# General Neighborhood Signs

# Avenue H at Prospect

W14-2

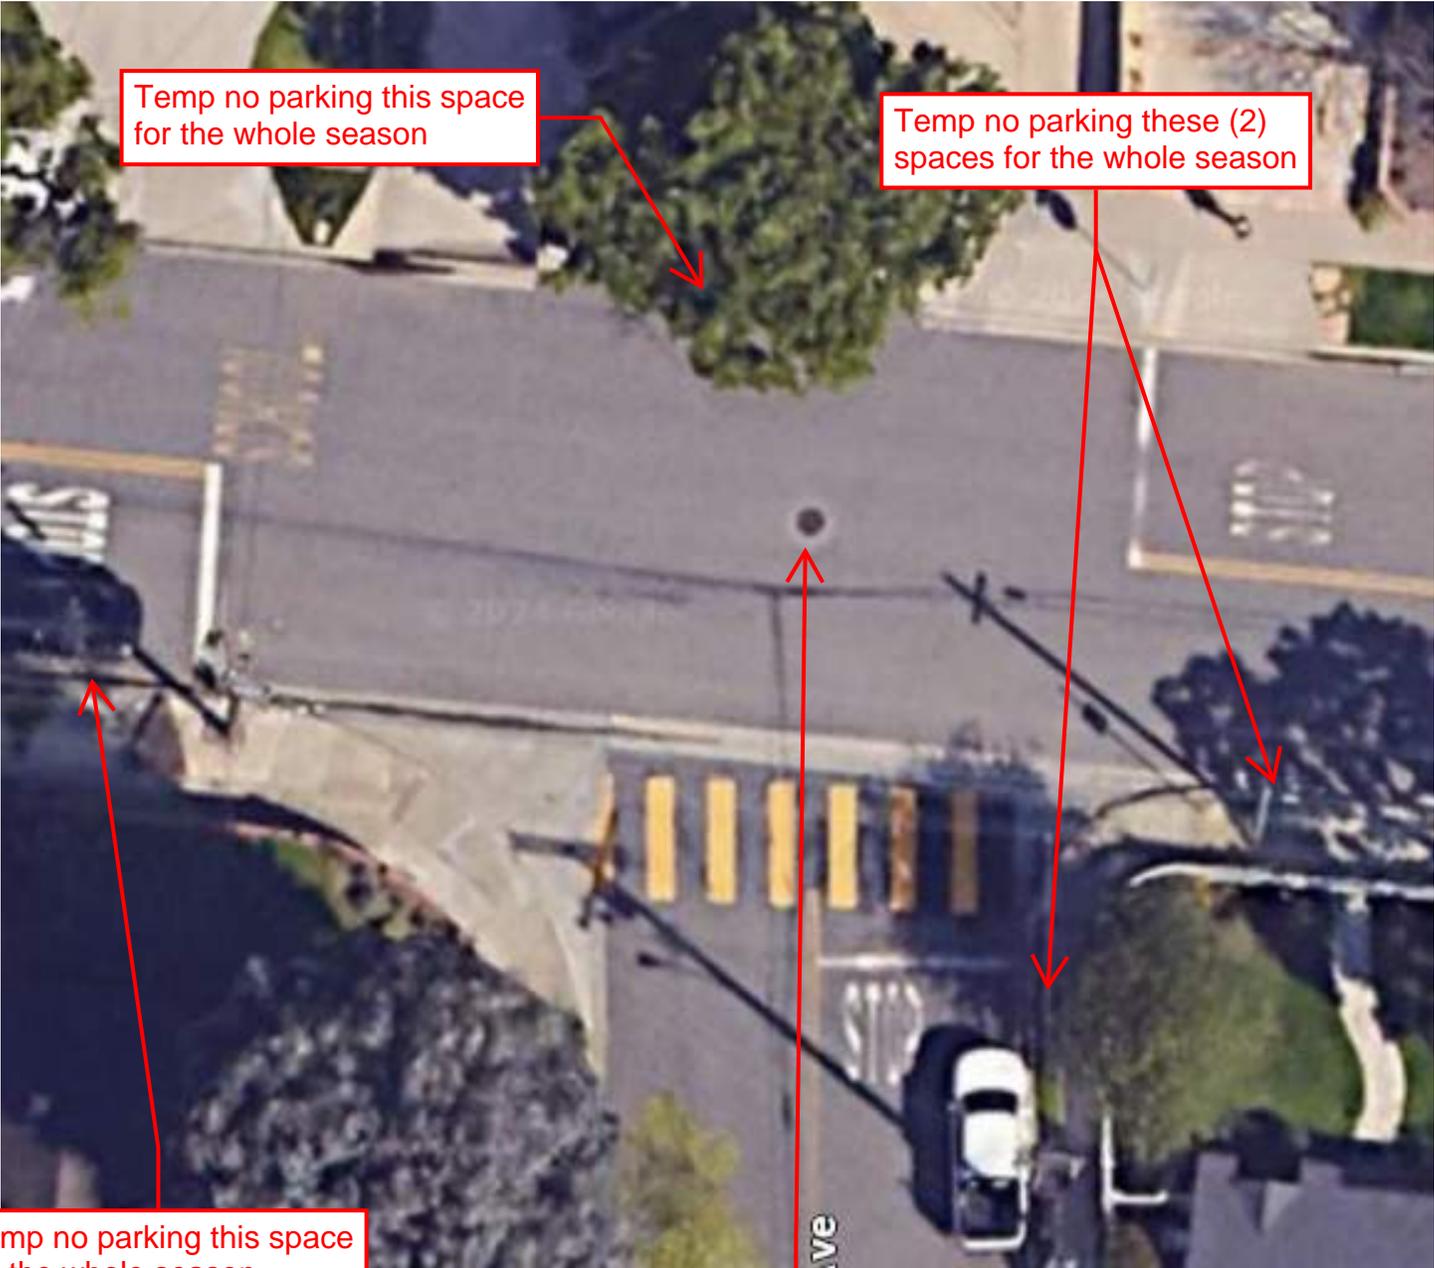
Signs on Type 2 barricades against curb in parking lane facing entry:

Type 2 barricade sign facing northbound approach

Add barricade light to each Type 2 barricade.

See what we can do to secure the barricades/signs

Below this sign, add green background sign with white text: "HOLIDAY LIGHTS" <up arrow>
